**Final
Technical Project Planning (TPP) Meeting No. 1
Memorandum
Former Richmond Naval Air Station
Former Incinerator
Remedial Investigation / Feasibility Study
Miami, Miami-Dade County, Florida
FUDS Project No. I04FL003806**

October 2015

FIGURE 2 – SITE MAP

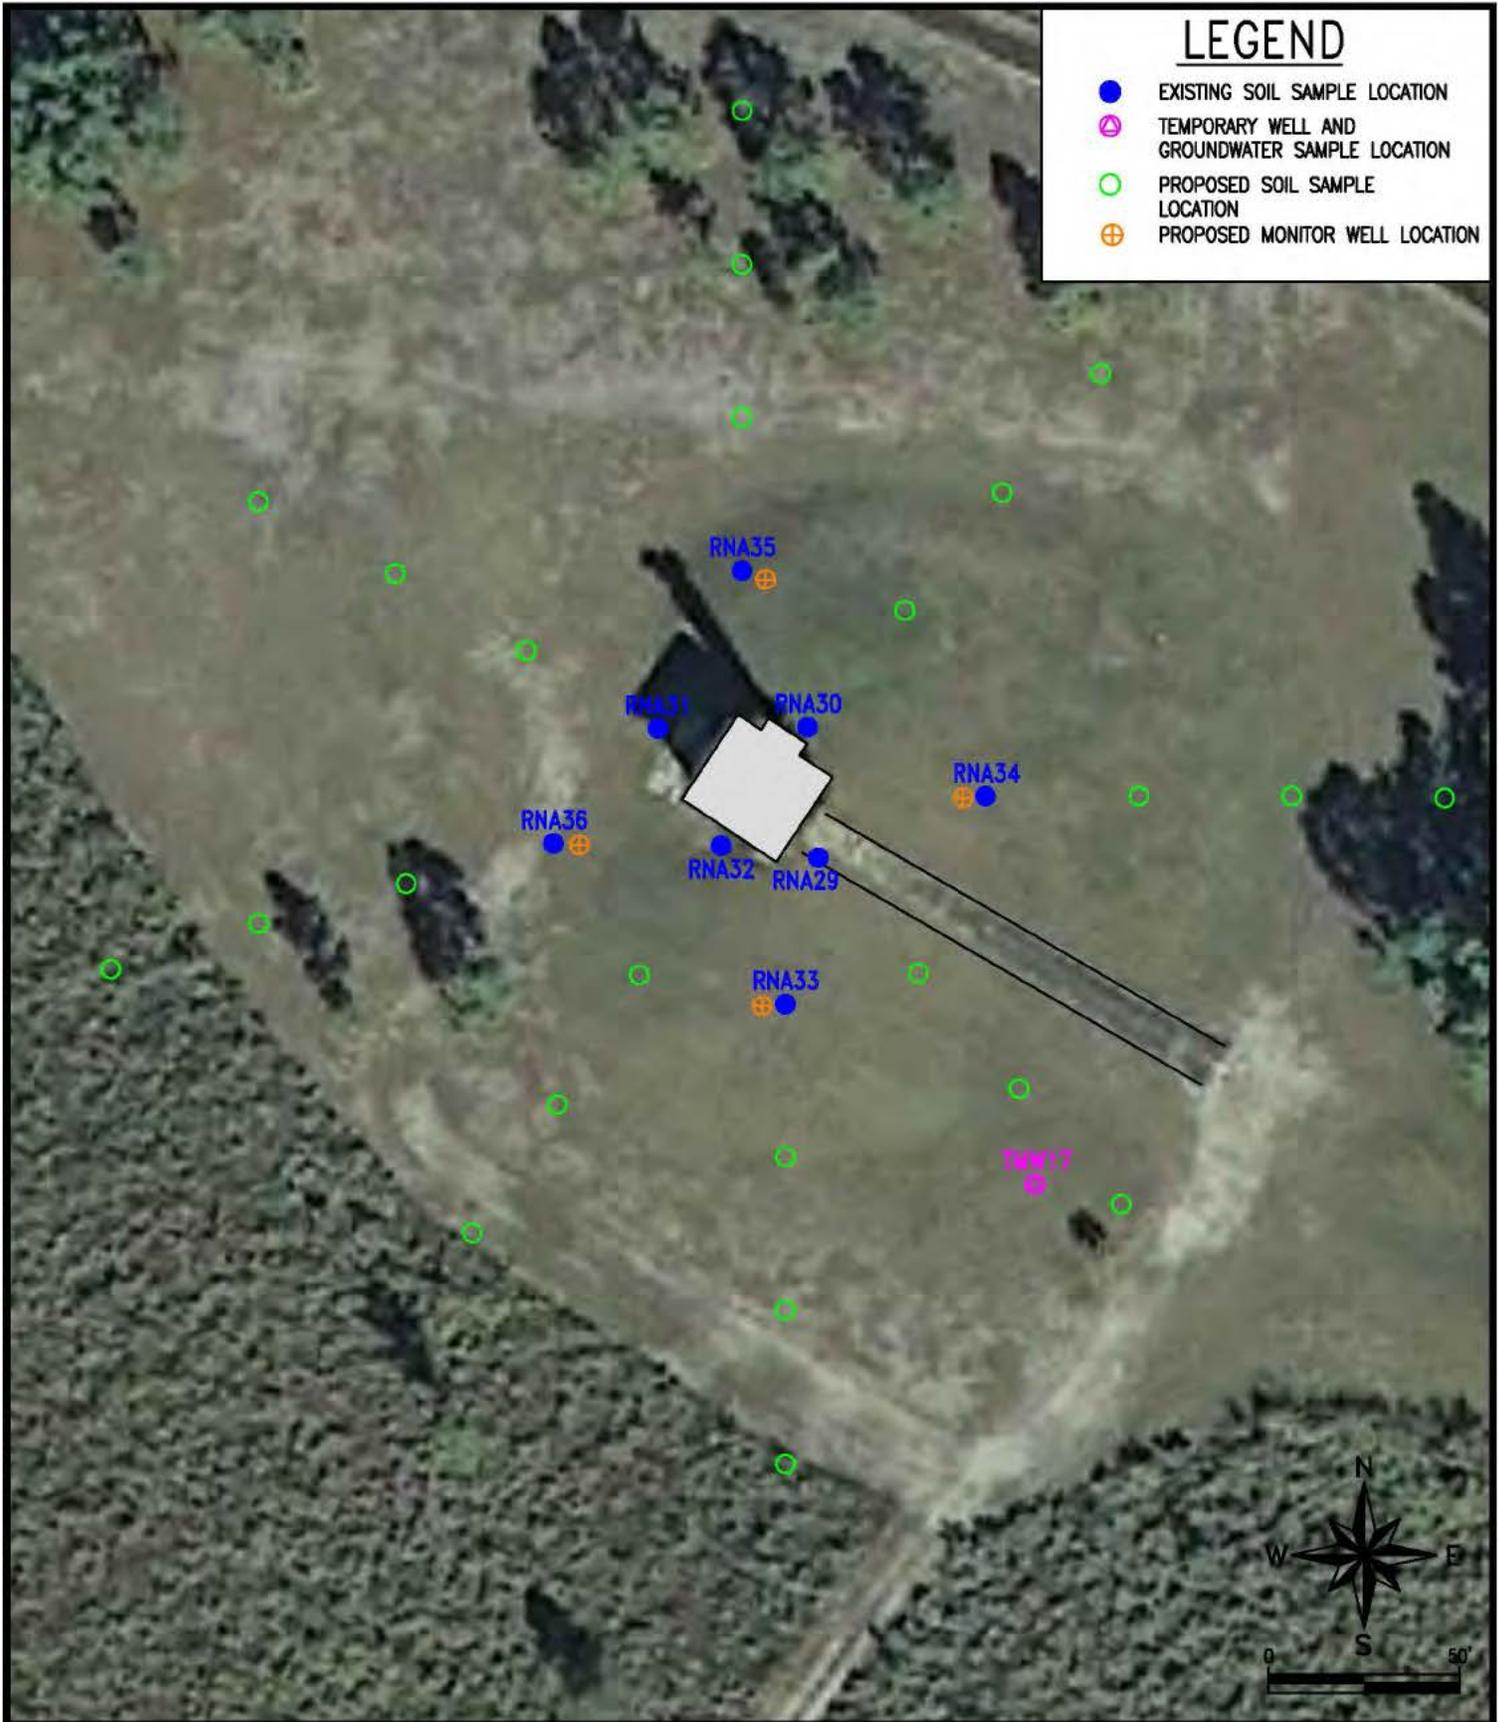
- The potential DoD COCs in the soil at the incinerator site are PAHs, BaPE, dioxins/furans, arsenic (As) chromium (Cr), and silver (Ag). Mr. Kux suggested that the USACE keep barium (Ba) and lead (Pb) in the soil and groundwater sampling program because they are key indicator parameters to identify incinerator material. Ms. Martuscelli said the USACE would evaluate the need to keep Ba and Pb in the sampling program. Mr. Young added that the Ba and Pb were not detected in the soil samples analyzed during the FDEP SI Report. Mr. Kux added information on the DERM Background Study on anthropogenic (caused by humans) arsenic levels in the soil. Mr. Kux stated that surface (0-0.5 feet BLS) soil sample concentrations for As were 7.0 milligrams per kilogram (mg/kg) and subsurface (0.5-2 feet BLS) soil sample concentrations for As were 5.0 mg/kg. The study found that the background concentration for arsenic for depths up to 2 feet BLS is 5.2 milligrams per kilogram (mg/kg). Therefore, 5.2 mg/kg will be the concentration used to determine if additional soil samples will be collected for arsenic analysis at depths up to 2 feet BLS. Aerostar added that the number of proposed As samples may change based on the information provided in the DERM As background study. Aerostar will use the DERM Anthropogenic Background Study arsenic concentration of 5.2 mg/kg as the alternative SCTL at depths of 0-0.5 feet BLS and 0.5-2 feet BLS. The default arsenic SCTL (2.1 mg/kg) and the existing background concentration detected in soil sample RNA-SB01 (2-4 feet BLS) will be evaluated for soil samples at depths of 2-4 feet BLS and 4-6 feet BLS. The USACE will add barium (Ba) and lead (Pb) to the soil sampling plan at the former incinerator. Ba and Pb will be

collected at depths of 0-0.5 foot BLS and 0.5-2 feet BLS at each sampling location. Aerostar does not anticipate collecting soil samples from 2-4 feet BLS at this time.

- During the Power Point presentation, Slide #16 illustrated the proposed soil sample locations surrounding the incinerator. Mr. Kux asked several question regarding the deposition of incinerator ash. Did the USACE considered atmospheric deposition over time? Was the incinerator ash used as fill? Was the ash deposited somewhere else on the base? Mr. Kux asked if the USACE were aware of any institutional knowledge regarding the deposition of the ash. He stated that there was a significant amount of military installation activity in the Miami area starting as far back as the 1920s. He stated that the installations were typically self-contained, all activities were performed on site and very little was taken off site. If that was the case, where did the ash go? Did anyone have knowledge of the incinerator operations? He stated that Mr. Jim McCarthy with FDEP interviewed several people during the SI to obtain knowledge of past operations. Mr. Kux again emphasized the need to keep barium and lead in the sampling list in case those two constituents were detected in isolated areas where Aerostar was collecting samples. The USACE and Aerostar will conduct historical research into the incinerator use during the RI/FS.
